## Report to the Hearing Committee on a notified resource consent application

- Activity:** To undertake construction works associated with the Pinehaven Stream Improvement flood mitigation works in the bed of the Pinehaven Stream.

- File Reference:** WGN200083
- Applicant:** Upper Hutt City Council
- Consents Sought:**
- [36459]: Discretionary Activity**  
Land use consent to undertake works in the bed of the Pinehaven Stream involving the placement, replacement and removal of structures; and the construction of naturalised channel banks, in relation to the Pinehaven Stream Improvement flood mitigation works, including associated disturbance and deposition to the streambed.

Figure 6: Map showing flood depth difference (from Technical Review revision 4 by Mr Law)

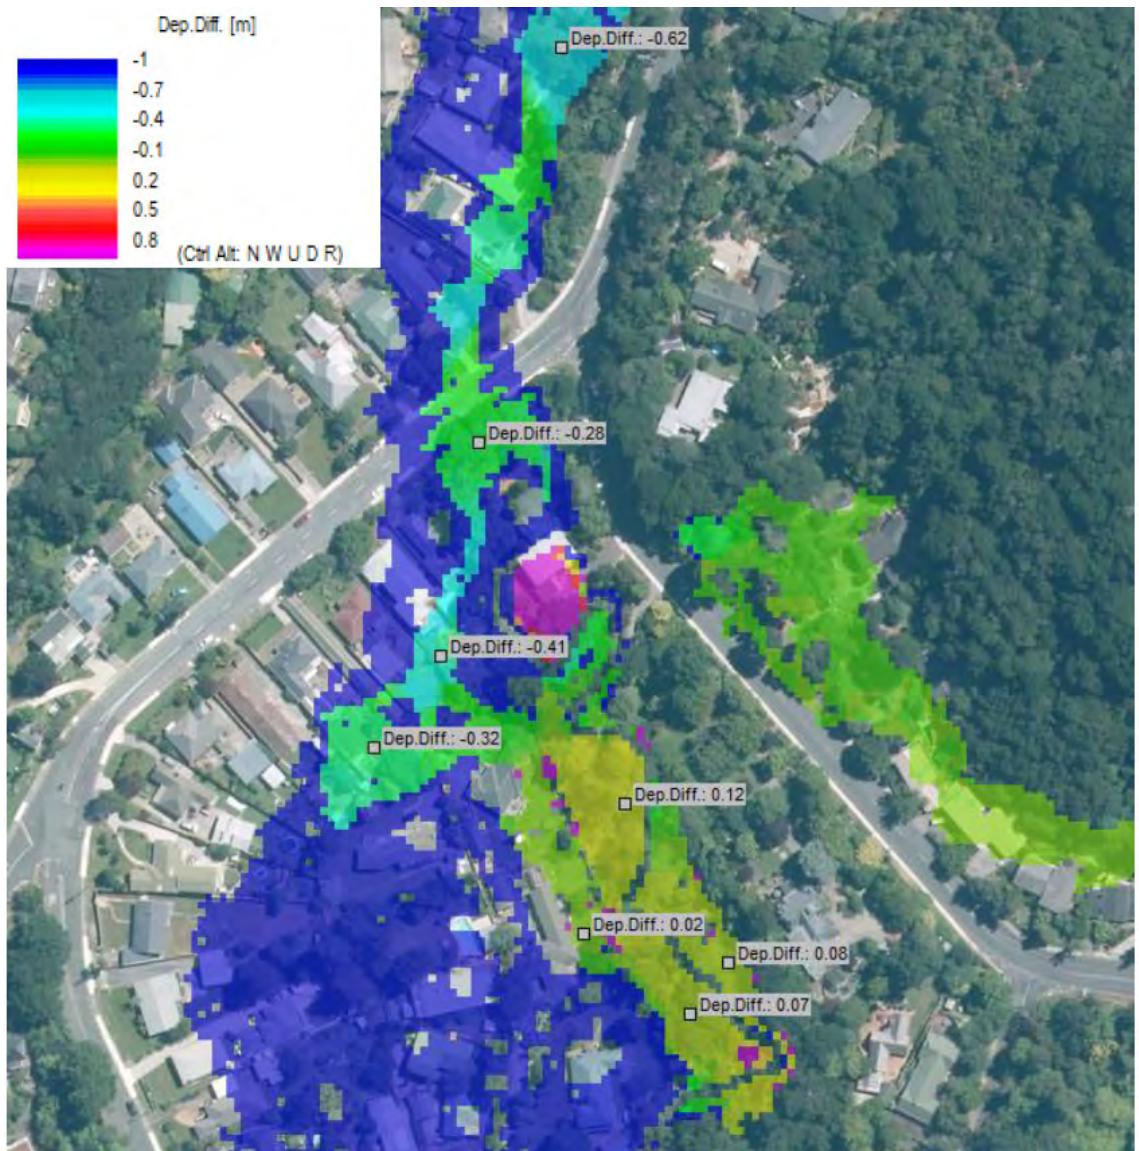
At Reach 3, the model indicates positive effects for a number of properties which I acknowledge but will not assess further in this section. The model does, however, indicate there may be some adverse effects for properties within Reach 3 (in relation to flood depth and flood extent). I have assessed the effects on these properties in Table 1 below, with references to the depth difference map provided in Mr Law’s review (and included as Figure 6 of this report).

Figure 4-4 Changes to DEM – Design model on the left and Base model on the right

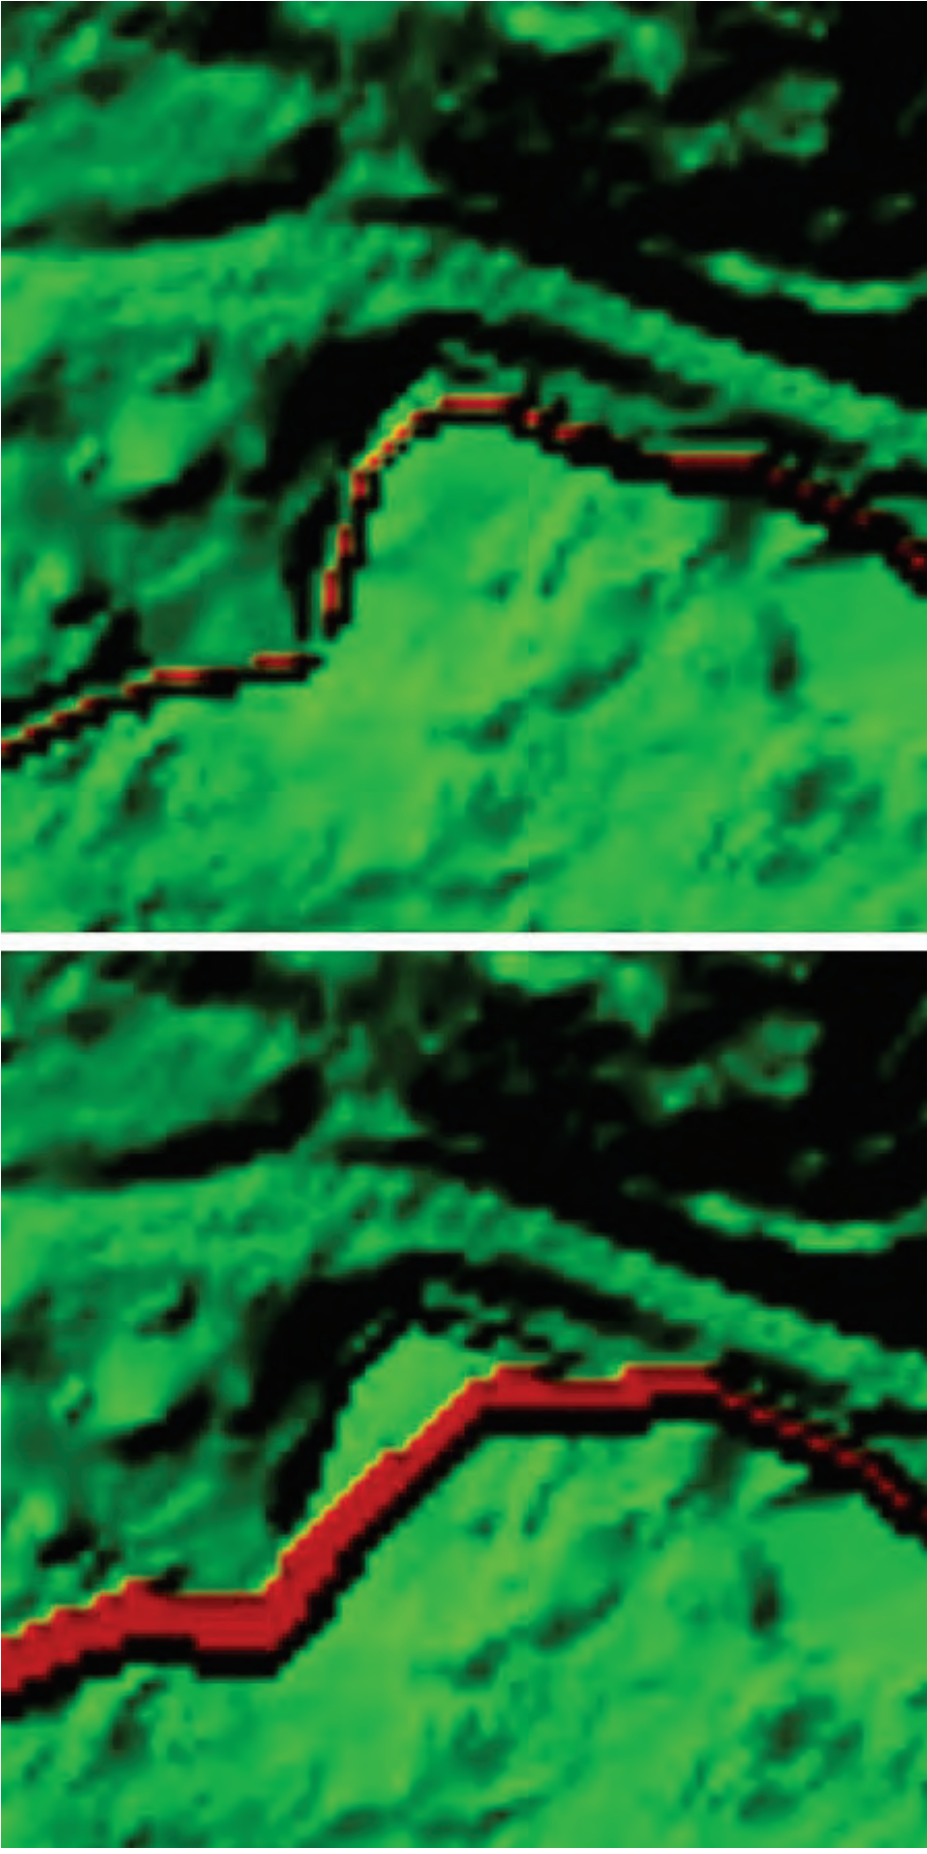
Item Checked	Findings & Comments	Modeller's response	Reviewer close out comments	Rating	Fit for use
<p><b>MIKE21</b></p>	<ul style="list-style-type: none"> <li>Model includes two gridded surfaces; representing Base (pre) and Design (post) proposed stream works</li> <li>Model updated with 2013 LiDAR</li> <li>The model uses a grid of 2x2 m. This is an appropriate level of detail, and more refined than the 5x5 m grid reviewed in 2015.</li> <li>The extent of the grid is such that the flood plain is covered. This is confirmed by the 100-year ARI results showing that no water is glass-walling at the edges of the grid.</li> <li>The Pinehaven Stream between Pinehaven Reserve and Whitemans Rd has been blocked out of the grid where M11 is present to prevent double counting.</li> <li>The blocking out has been increased in areas of stream widening (this matches changes to the M11 cross-sections) as indicated by the red areas in Figure 4-4.</li> <li>The stream centreline and mesh blackout at 28 Blue Mountains Rd between the Design model and Base model is slightly different.</li> </ul>	<p>Agreement with findings and comments noted.</p>	<p><b>CLOSED</b></p>	<p><b>0</b></p>	<p><b>Yes</b></p>

Figure 4-6 Cross-section 1496

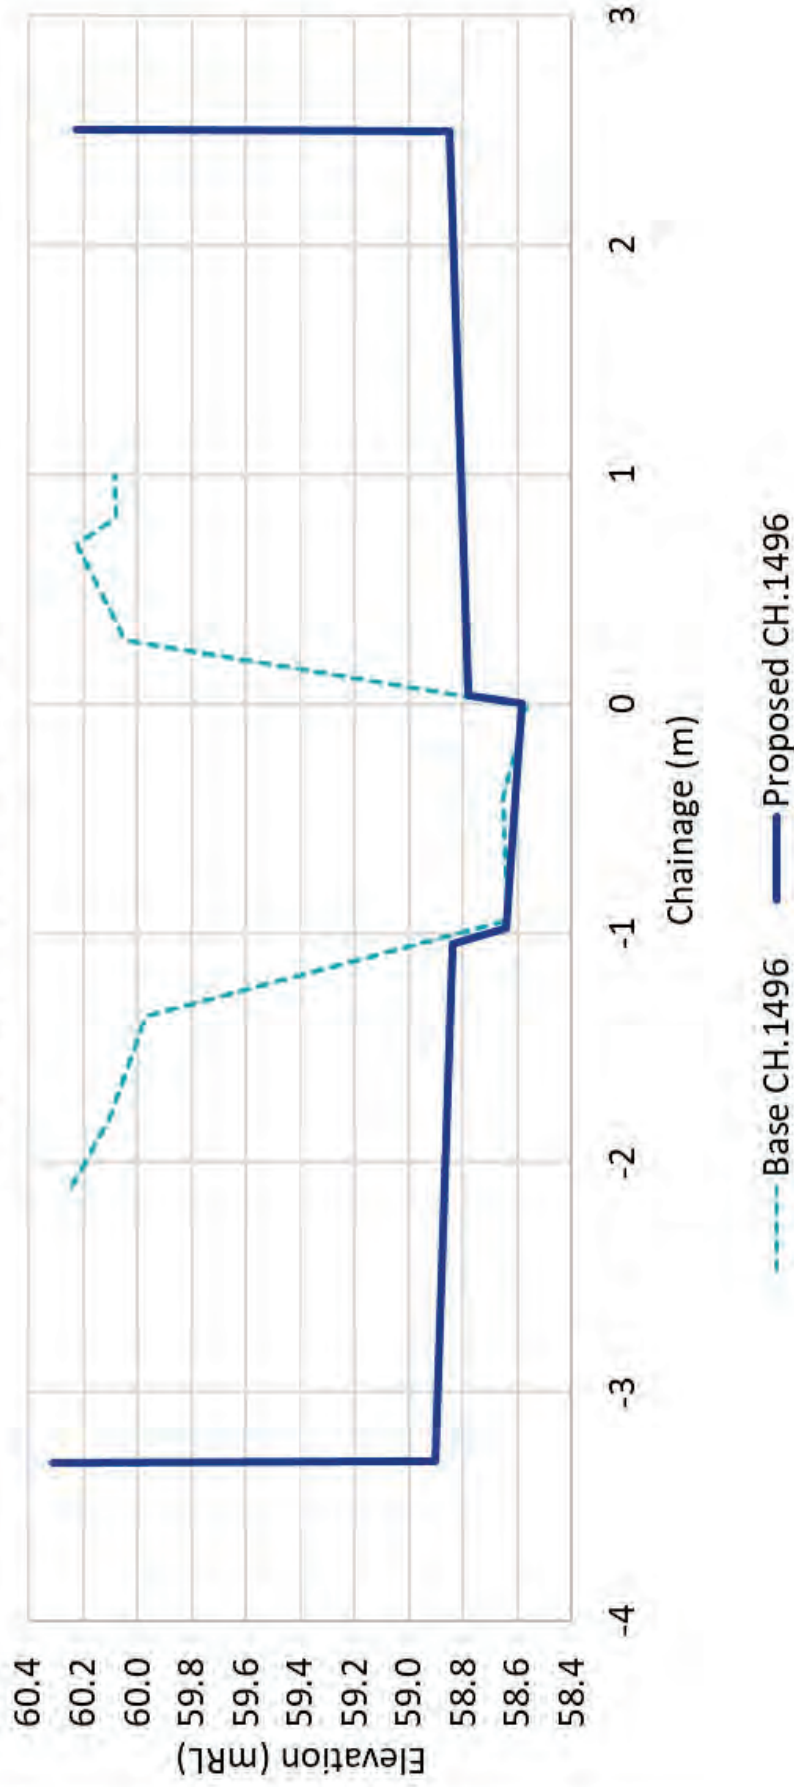
Coupling parameters	Default figures have been used	Noted; agreement with comment.	CLOSED	0	Yes

Figure 4-8 100-year ARI long-section

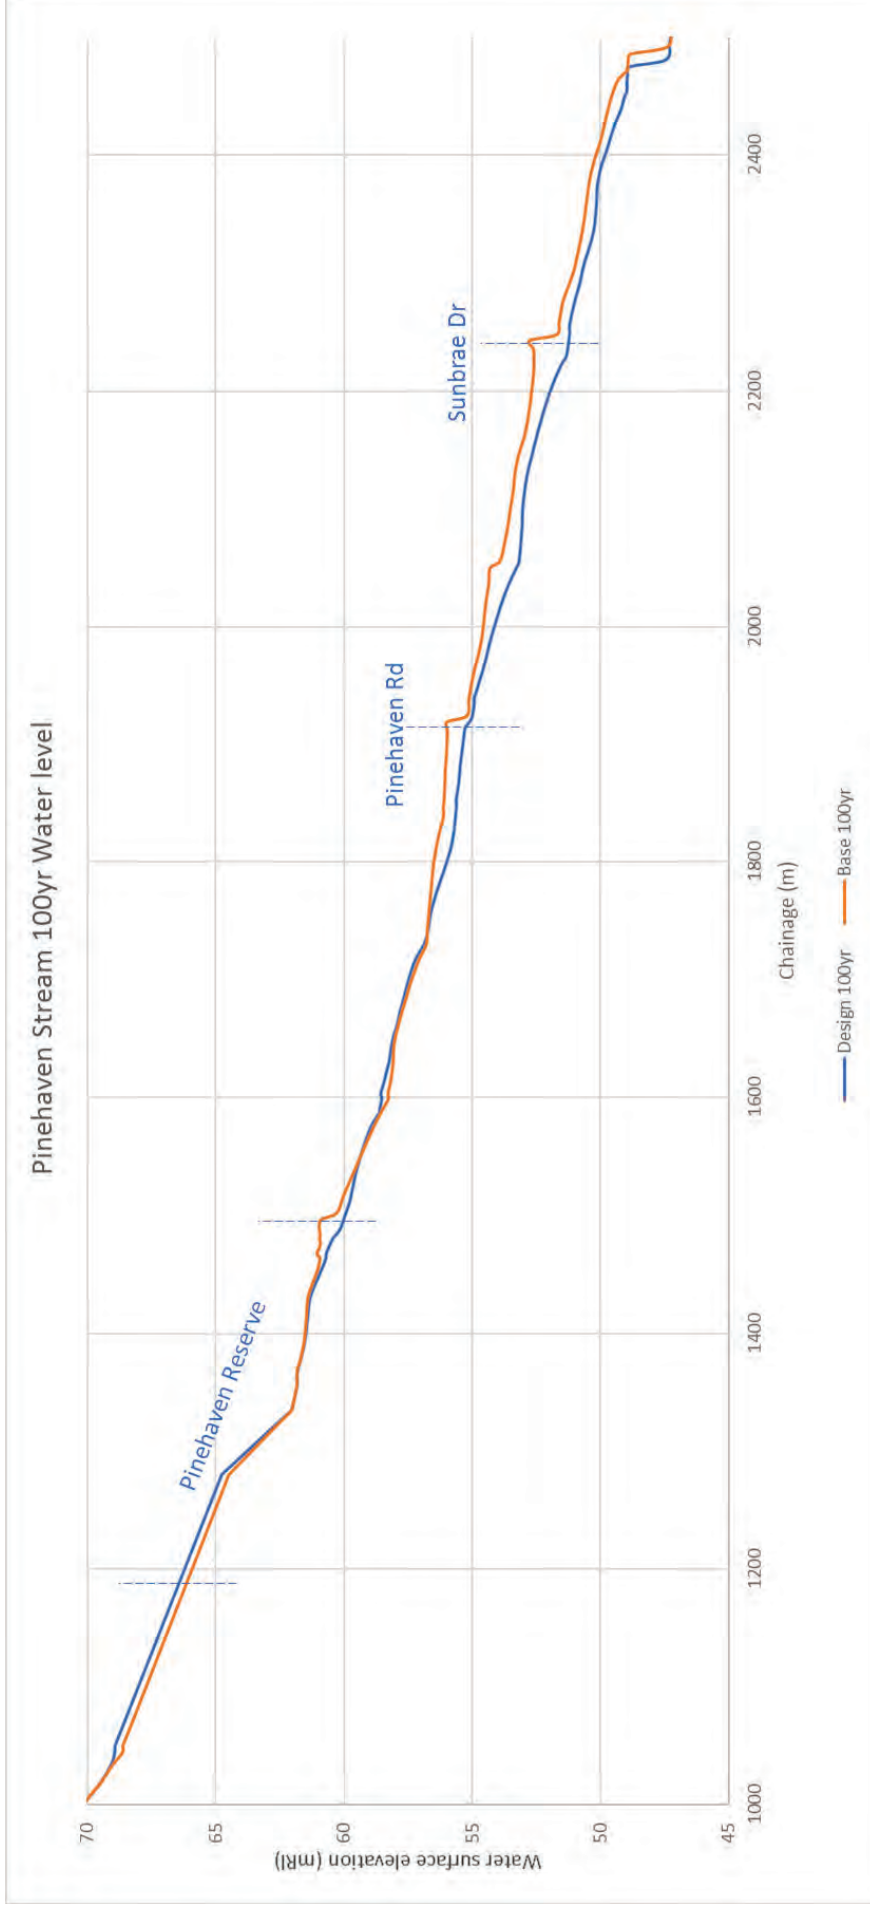
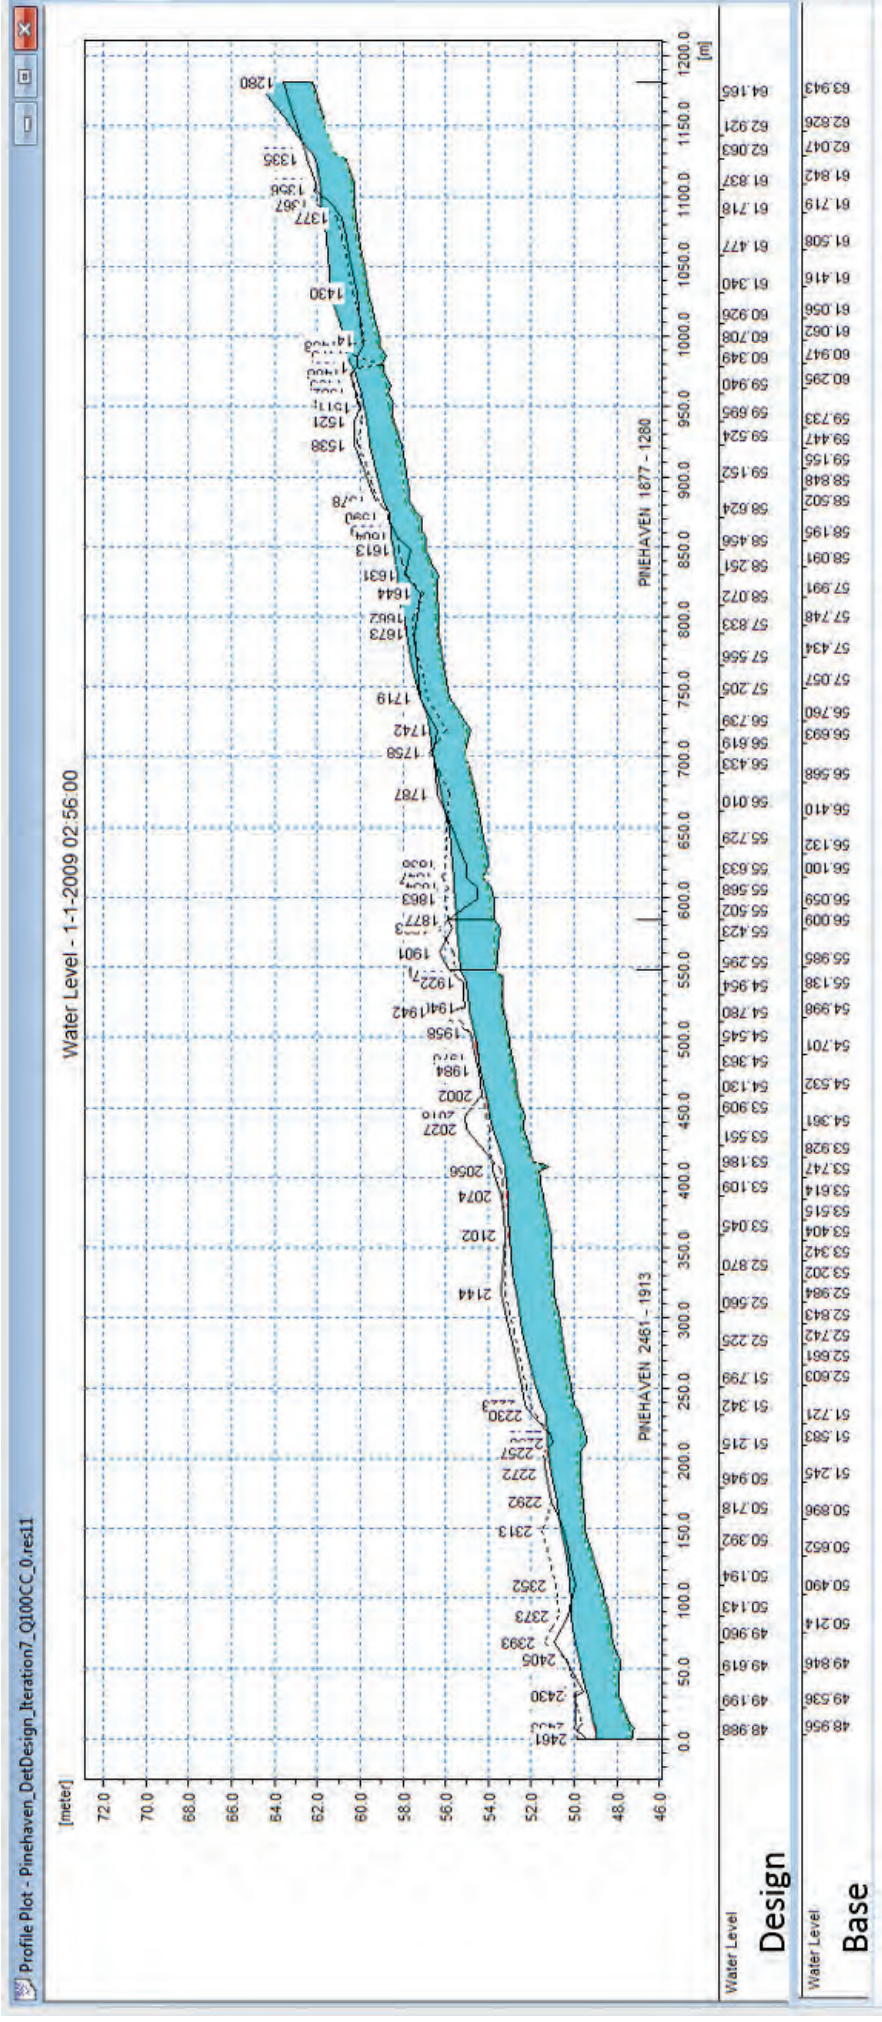
MIKE11 Water levels	The HGL plot in Figure 4-8 and Figure 4-9 shows that the 100-year ARI event water levels are reduced in most stretches of the stream due to the stream widening and larger culverts. Two sections have increased in water level. <ul style="list-style-type: none"> <li>The piped section in and upstream of Pinehaven Reserve. This is unexpected, as we assumed that there were no changes in this reach and do not expect it to be affected by the stream works. Is the modeller able to explain this?</li> <li>A short section at Ch. 1600. Near 2A Freemans Way (as stated in the executive summary of the Flood Hazard Assessment report)</li> </ul>	The piped section in Pinehaven Reserve was not checked because it is outside the area of main channel works. Differences in water level do not affect containment within the channel (as this is a piped section) or habitable floor flooding (as the area is a reserve). Near 2A Freemans Way there are no channel works proposed. The differences are thought to be due to a combination of channel works upstream directing more flow into this reach instead of entering the Birch Grove area and a slight change in timing of the flood peak.	Uncertainty over the cause of the raised water levels through the reserve is not expected to adversely affect the relative effects of the stream works, and so does not materially affect the 'fit for use' categorisation.  However, the Reviewer notes that the issue is not resolved and so the issue will remain open  <b>OPEN</b>	2	Yes

Figure 4-7 Cross-section 1496 (proposed as per June 2020)

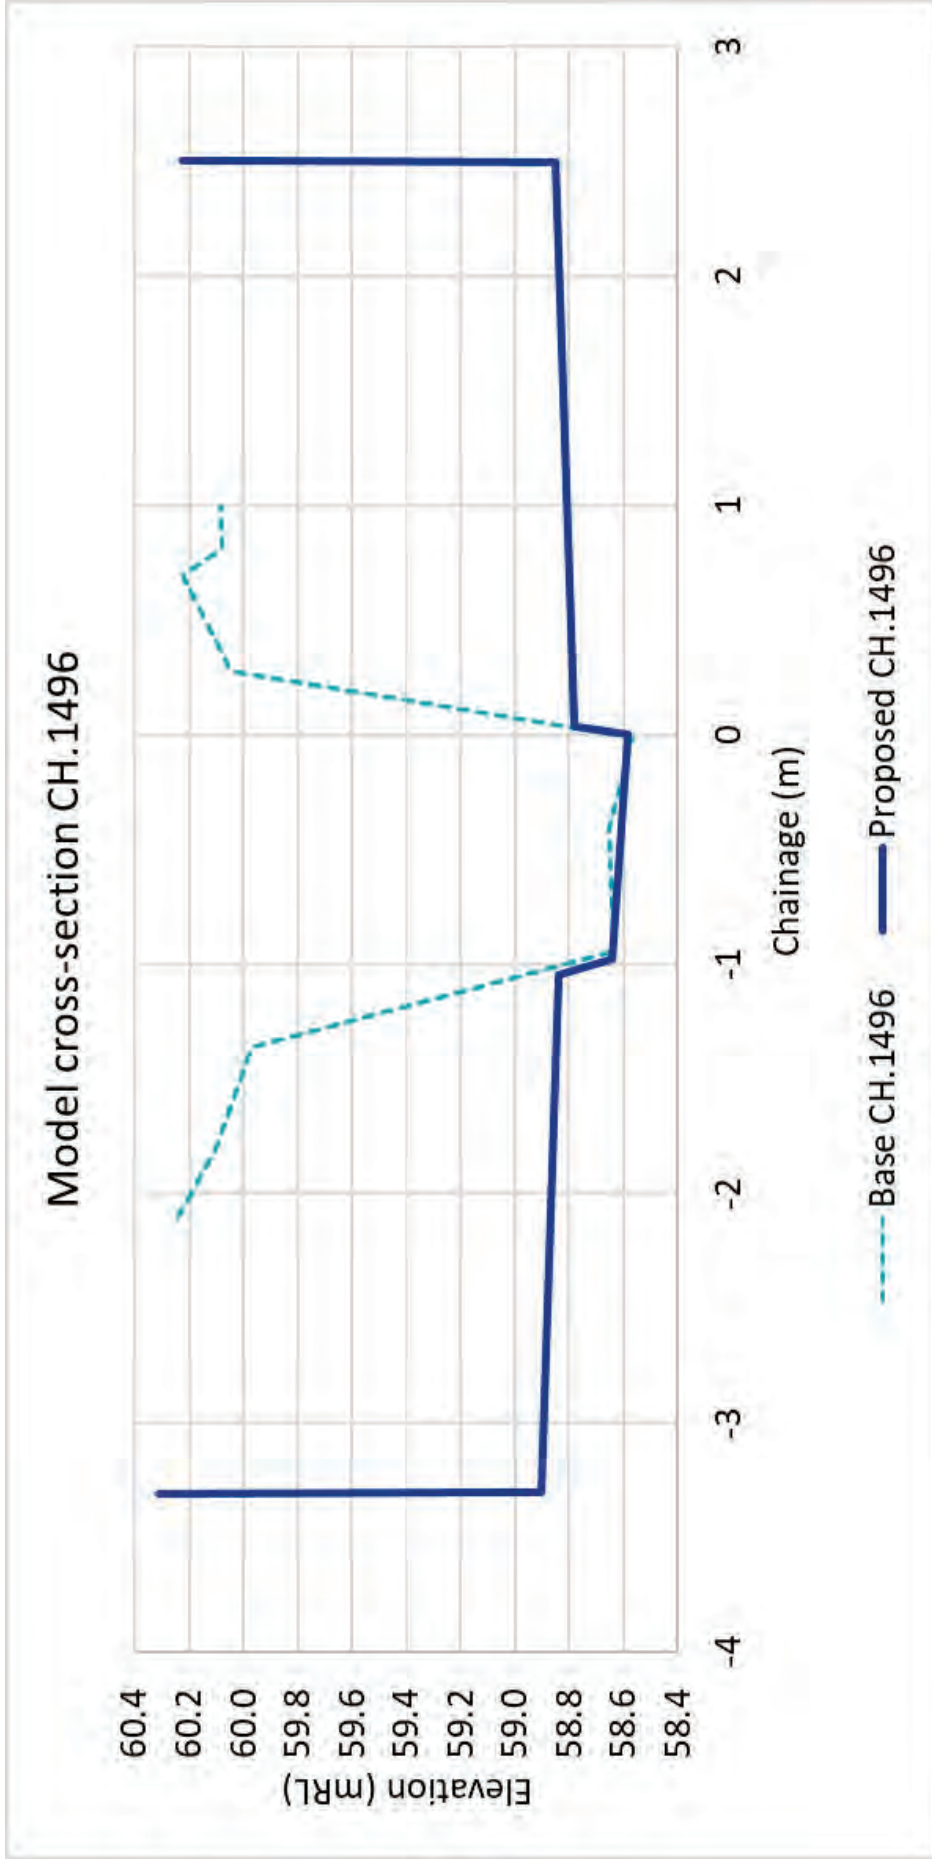
<p><b>June 202 Update</b></p> <ul style="list-style-type: none"> <li>There have been some changes to the design cross-sections (see Figure 4-6). We assume these are the final design cross-sections. Results still show flooding to be reduced (in most places) as a result of the design cross-sections (See FHIA for more commentary on results).</li> </ul>		<p><b>CLOSED</b></p>	<p>1</p>	<p>Yes</p>
